EC135 ALERT SERVICE BULLETIN

Indicating and Recording Systems – Instrument Panel – Inspection and modification of switches ENG CONTROL on switch unit 20VE

Inspection of Locking Groove
Figure 1

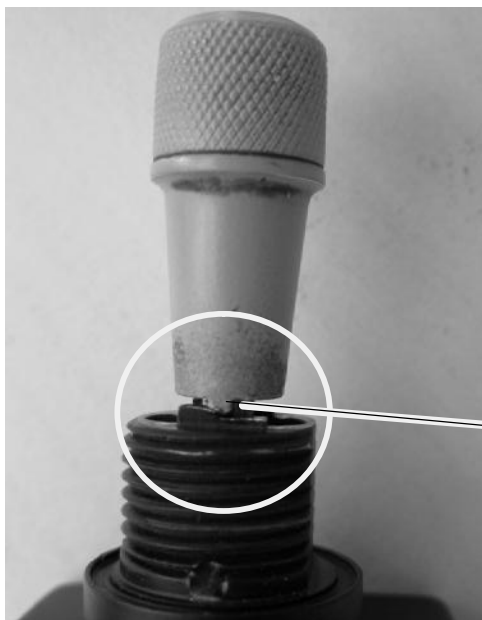
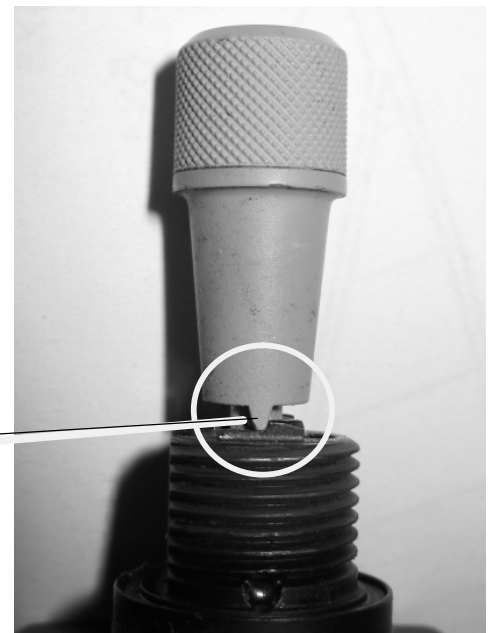
- (1) De-energize helicopter electrical system i.a.w. AMM, 24-00-00, 2-1.
- (2) Set switch lever ENG CONTROL (1, Figure 1) to position FLIGHT.
- (3) Accomplish a visual check of the locking groove (2, Figure 1) for signs of wear.
- (4) Check, that the switch ENG CONTROL can not be set from position FLIGHT to position IDLE by applying low pressure, but without pulling the switch lever (1, Figure 1, View A).
- (5) If switching is possible or the locking groove has visible signs of wear switch ENG CONTROL must be replaced as follows:
 - (a) Remove switch unit 20VE i.a.w. AMM, 31-11-20, 4-1.
 - (b) Fold up switch lock (5, Figure 2) of the switch to be replaced. Loosen nut using a suitable tool and pull out switch (6).

Typical Switch Unit 20VE
Figure 2

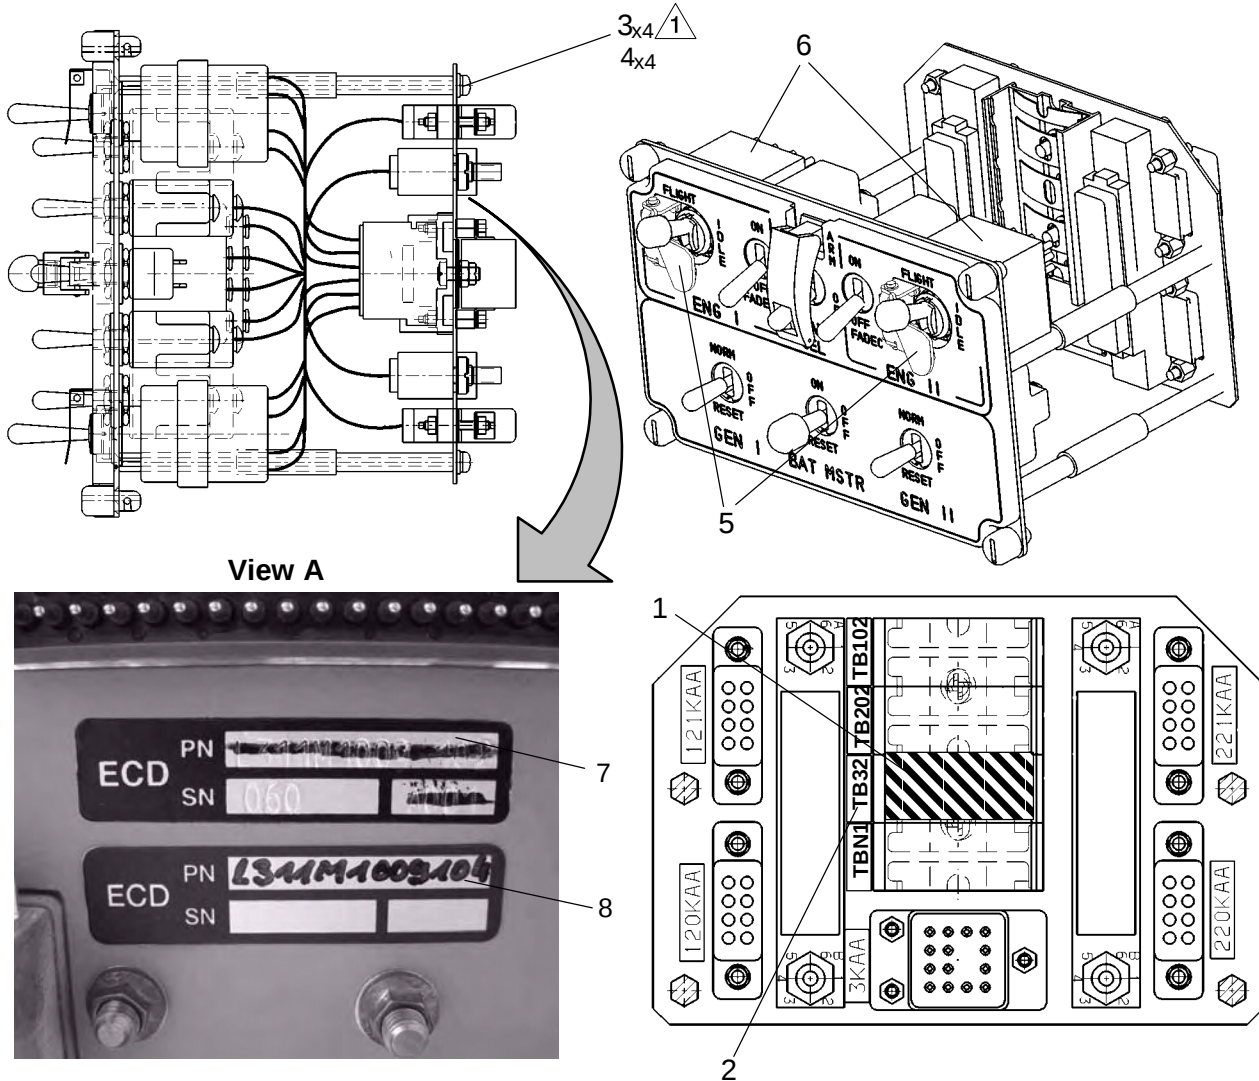
- (2) Remove switch unit 20VE i.a.w. AMM, 31-11-20, 4-1.
- (3) Fold up switch lock (5, Figure 2) on switch (6). Loosen nut using suitable tool and remove switch lock.
- (4) Install switch with new switch lock and error-proof positioner in switch unit 20VE. Attach nut with suitable tool.
- (5) Check switches ENG CONTROL with switch lock:

- (5) Install module TB32 (1, Figure 2) in switch unit 20VE.
- (6) Affix placard (2).
- (7) Disconnect the wires mentioned below from switch unit (see WDM 80-00-11):
 - Wire 8001-1151 from 20VEA Pin 4
 - Wire 8001-1169 from TB102 Pin M
 - Wire 8001-1251 from 20VEB Pin 4
 - Wire 8001-1269 from TB202 Pin M
- (8) Reroute disconnected wires i.a.w. Table 1 or Wiring Diagram (Figure 6) and attach to installed wire harnesses by means of lacing tape. Cut off contacts and crimp on new contacts i.a.w. Table 1.
- (9) Route new wires i.a.w. Table 1 or Wiring Diagram (Figure 6) and attach to installed wire harnesses by means of lacing tape.
- (10) Strip wires i.a.w. Table 1. Crimp on contacts and insert in respective component.

- (1) Using a permanent, black pen, cross out old part number on placard (7, Figure 2) of switch unit 20VE but leave it still legible.
- (2) Affix new placard (8, Figure 2) next to the already affixed placard.

(21) Install rear plate to switch unit 20VE using screws and washers (3, 4, Figure 2). Secure screws (3) with locking fluid (CM 620).

Possible Variants of Switch Units (up to and including H/C S/N 0168)
Figure 3

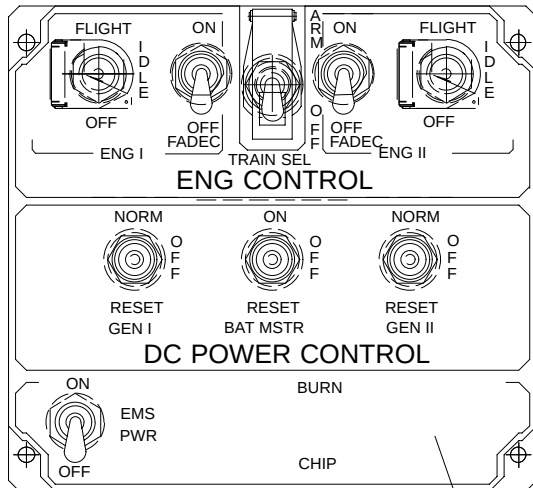
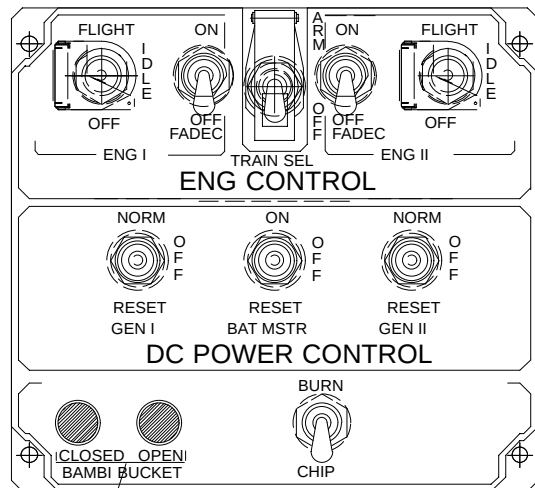
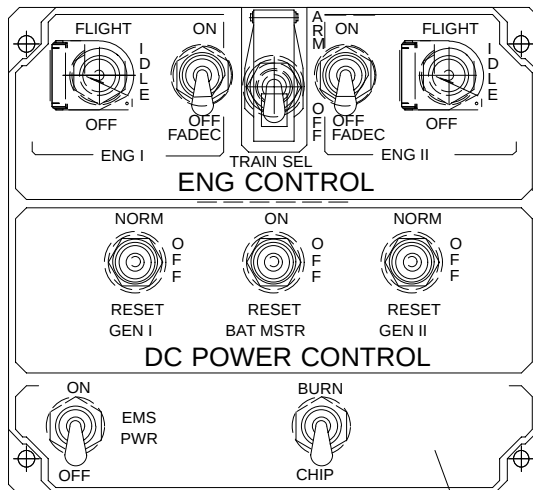
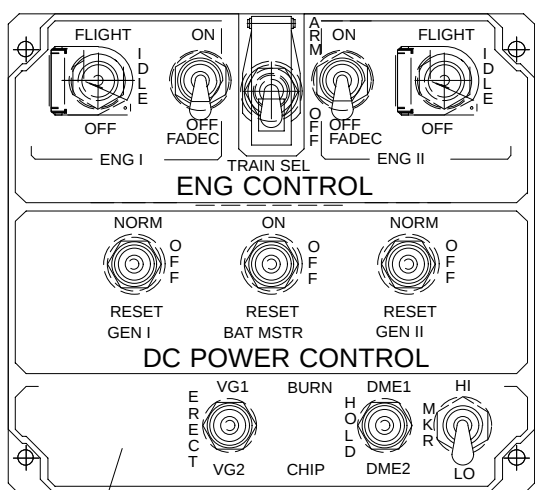
NOTE On helicopters up to and including S/N 0168 a switch unit can be installed that has an additional switch row (see Figure 3, 4) with part numbers L311M1085101 up to and including L311M1085109. For the wiring of the additional switch levels the same instructions are applicable as for switch unit L311M1034102.

- (3) Compare switch unit with the possible variants shown in Figure 3 – Figure 5 and verify new part number.
- (4) Using a permanent, black pen, write verified part number onto placard (8, Figure 2).
- (5) If switch unit 20VE cannot be verified contact ECD customer support.

Figure 7

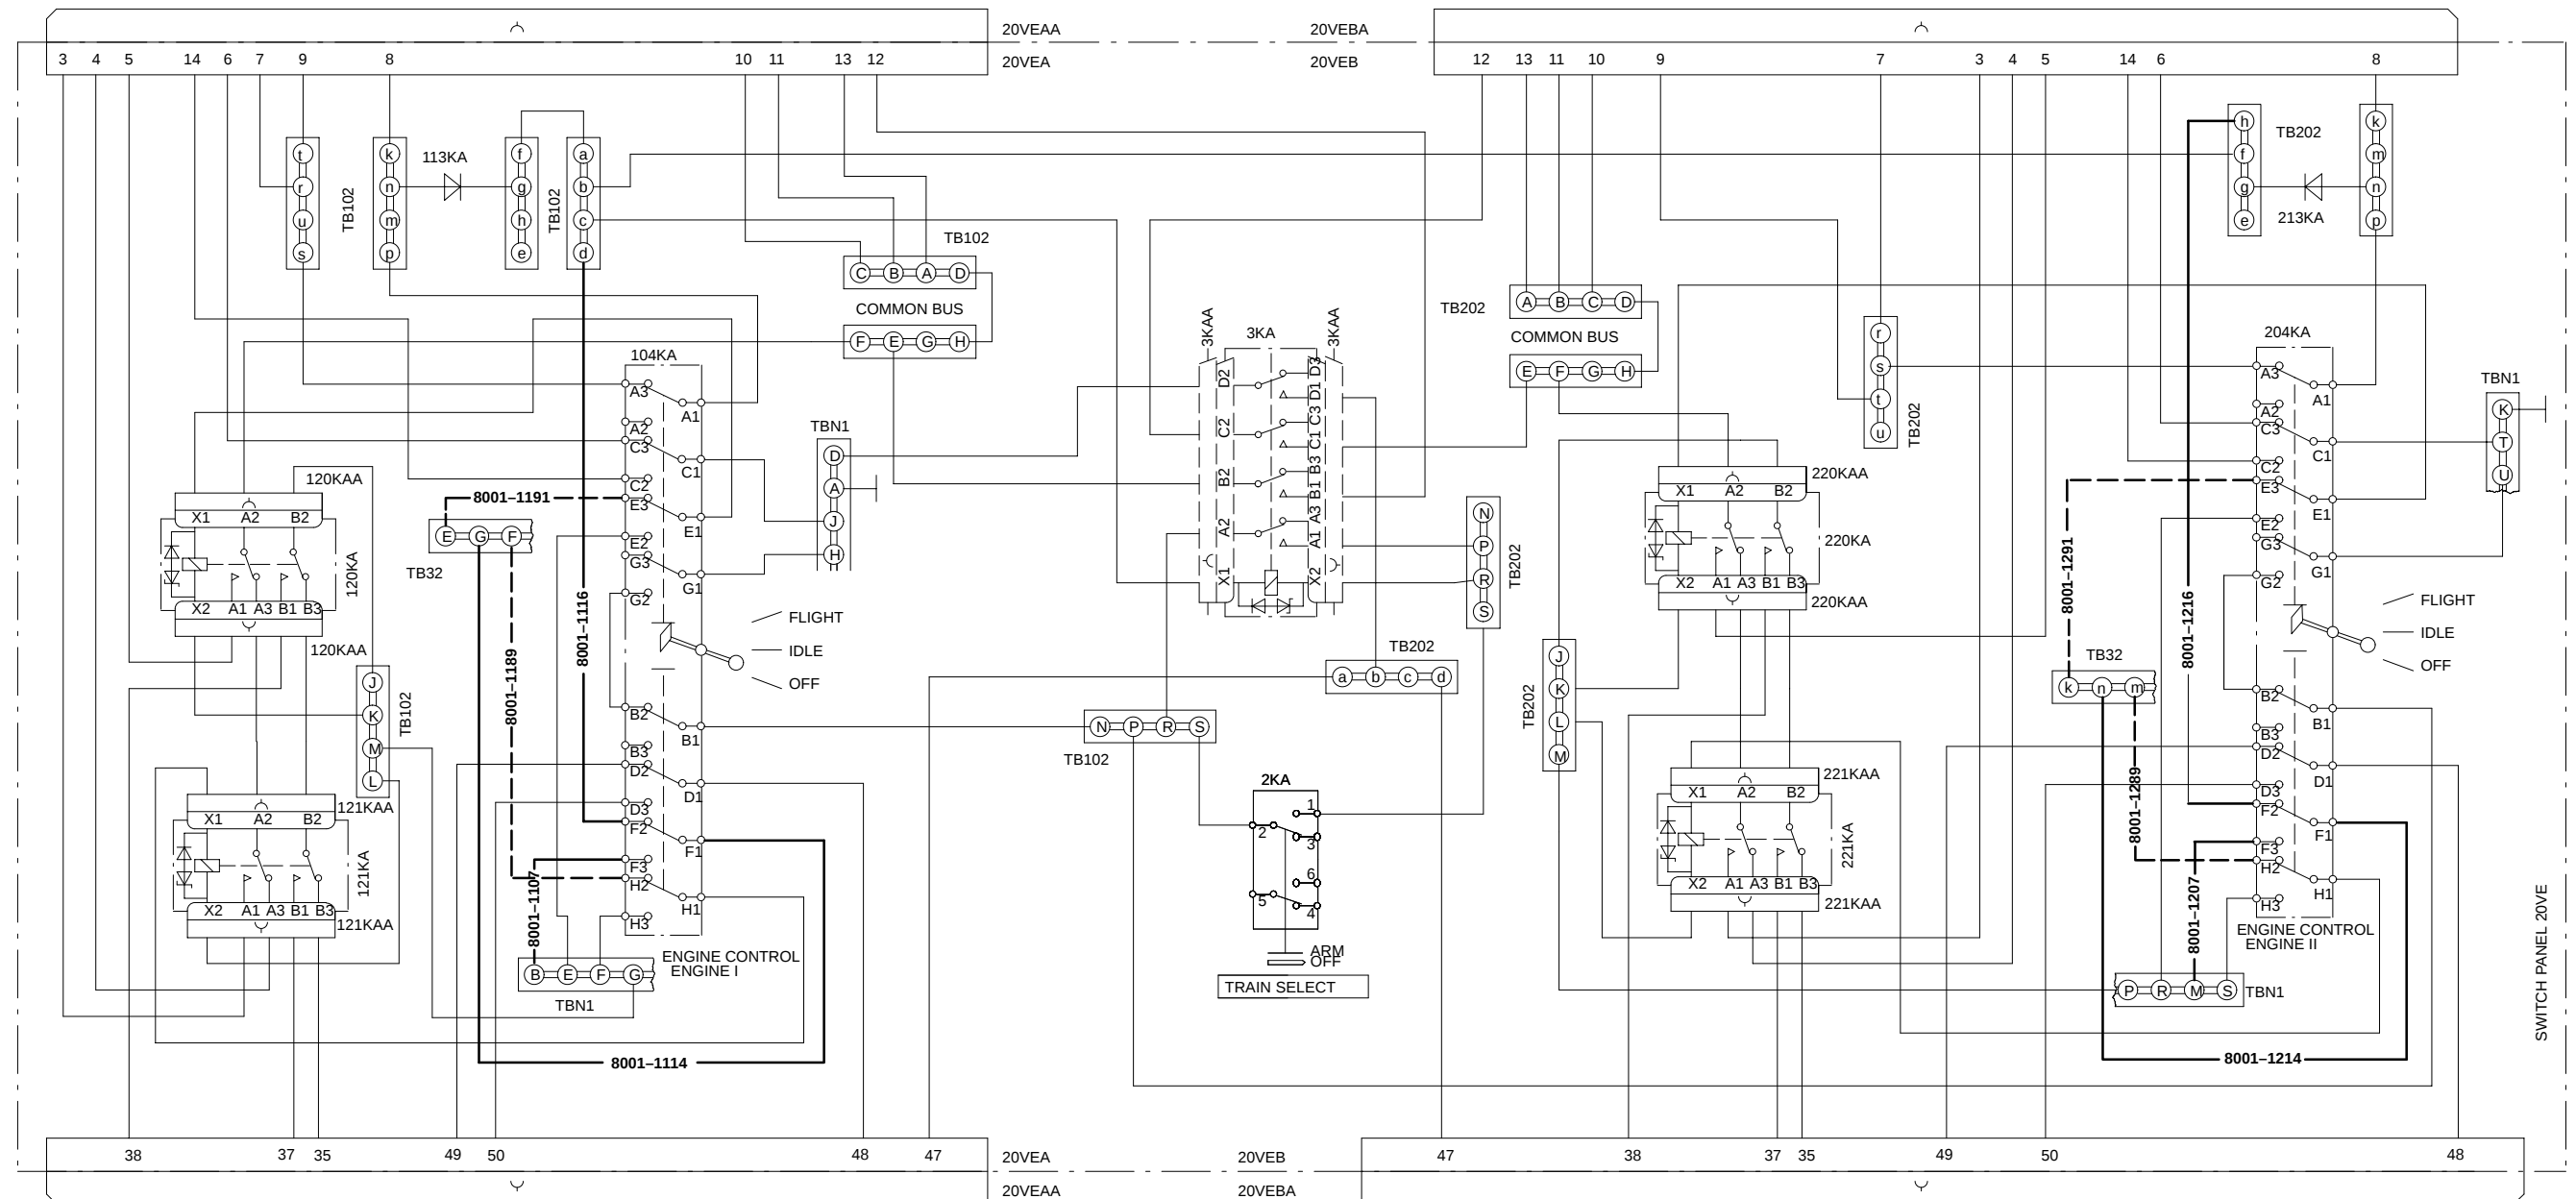
(14) Reroute disconnected wires i.a.w. Table 2 or Wiring Diagram (Figure 7) and attach to installed wire harnesses by means of lacing tape.

(15) Reroute new wires i.a.w. Table 2 or Wiring Diagram (Figure 7) and attach to installed wire harnesses by means of lacing tape.

Wiring Diagram after Accomplishment of ASB EC135-31A-045
Figure 8

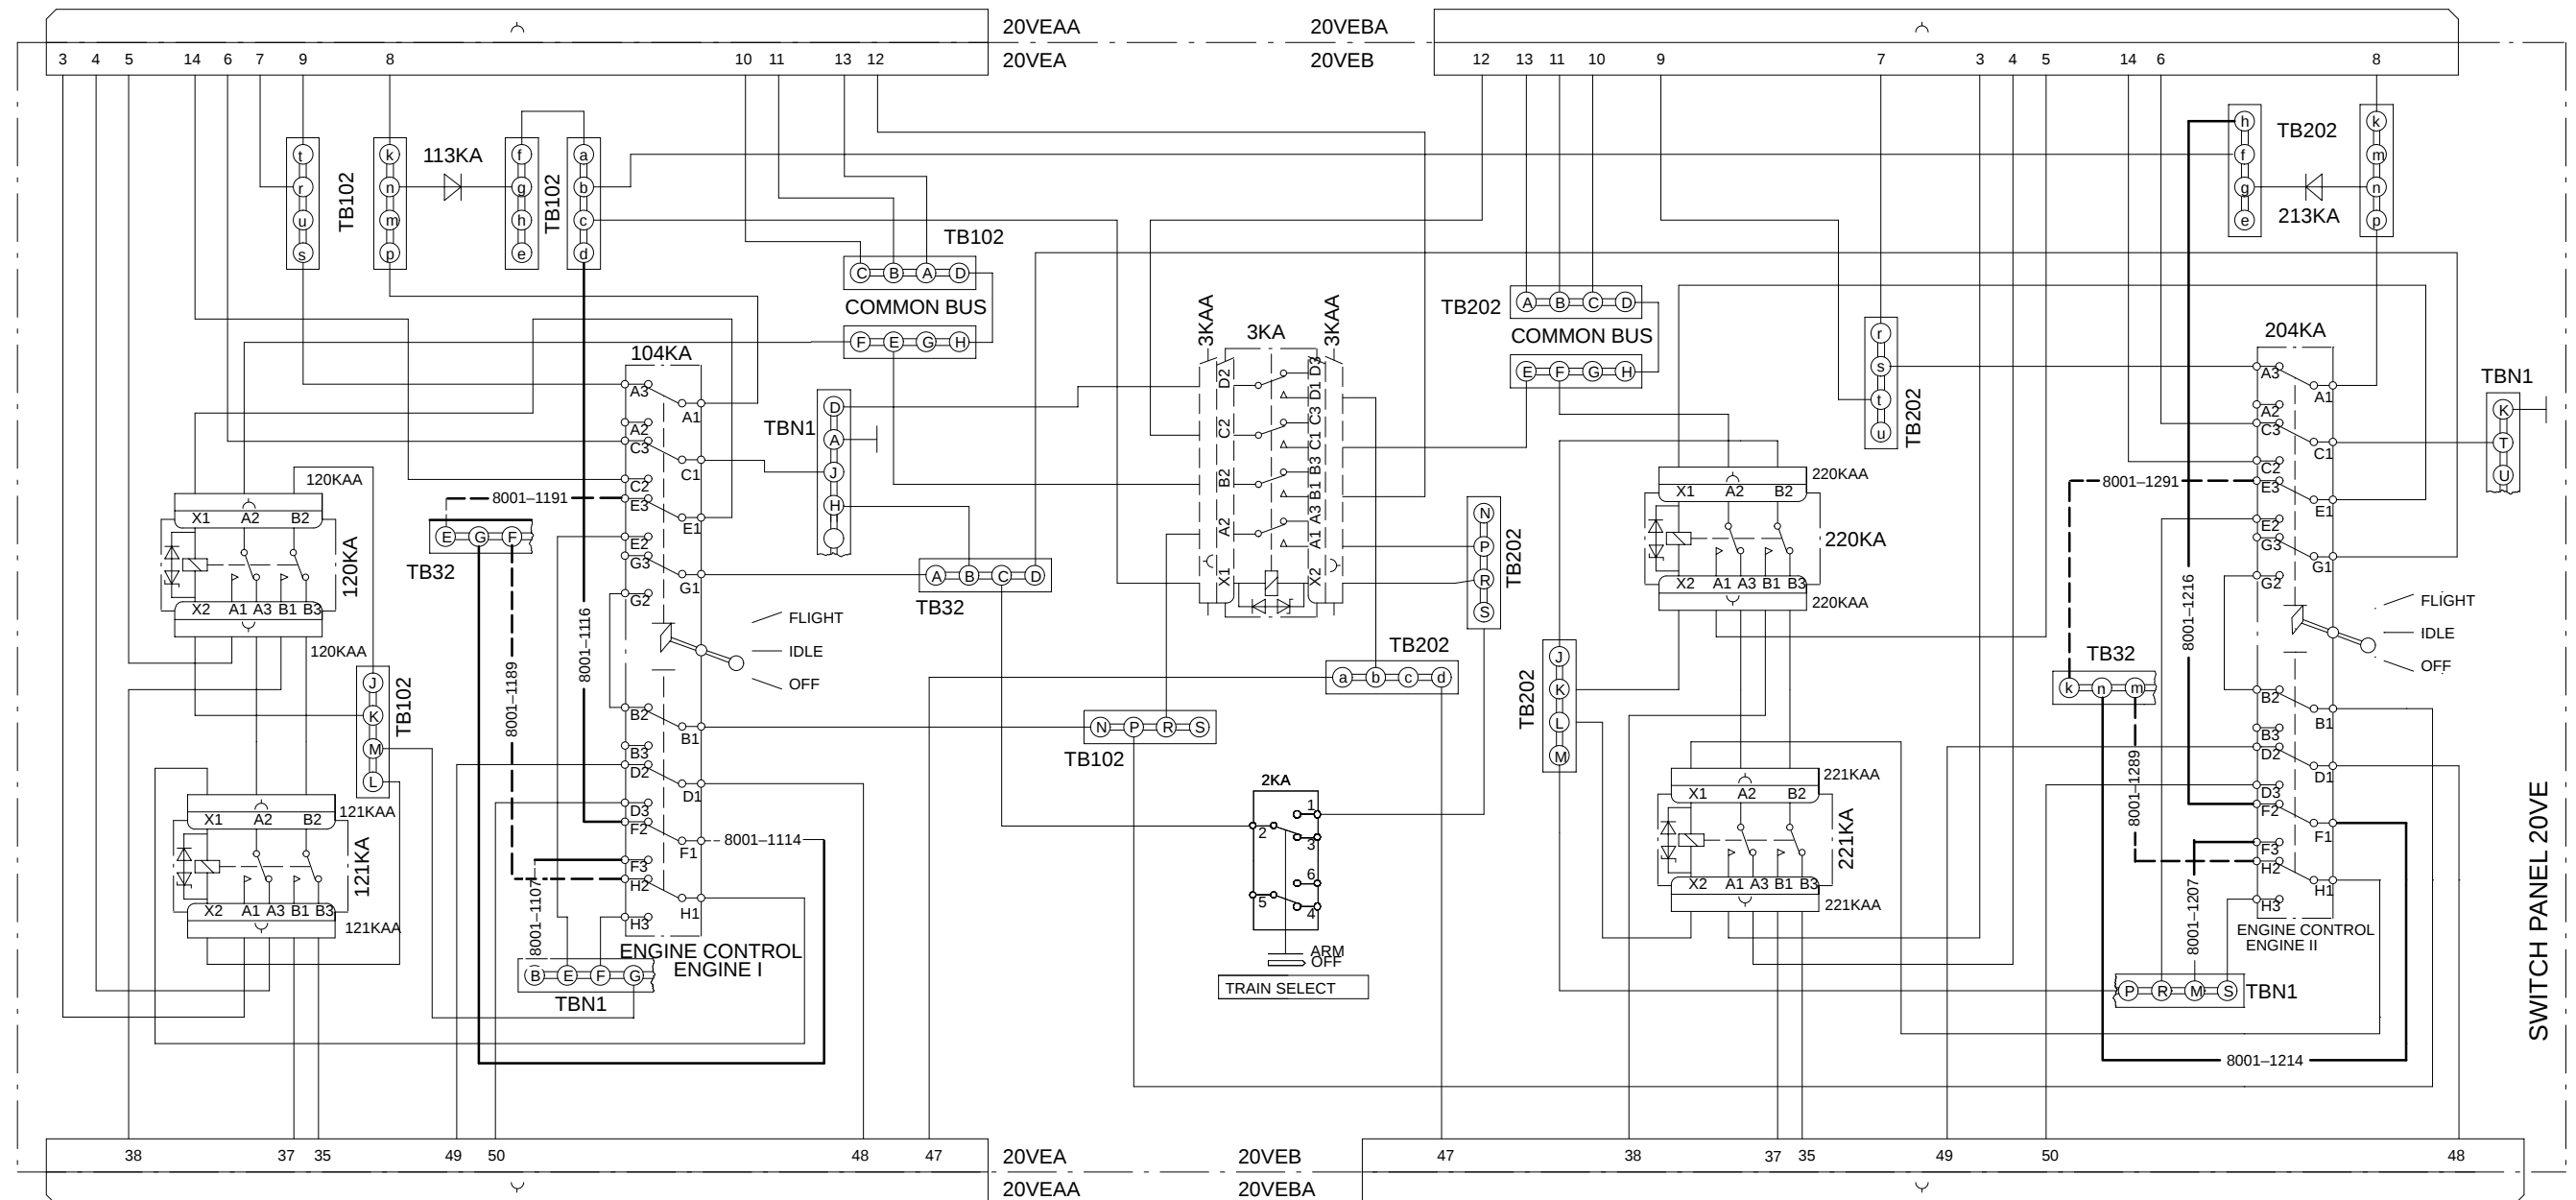
(18) Reroute disconnected wires i.a.w. Table 3 or Wiring Diagram (Figure 8) and attach to installed wire harnesses by means of lacing tape.

(19) Reroute new wires i.a.w. Table 3 or Wiring Diagram (Figure 8) and attach to installed wire harnesses by means of lacing tape.
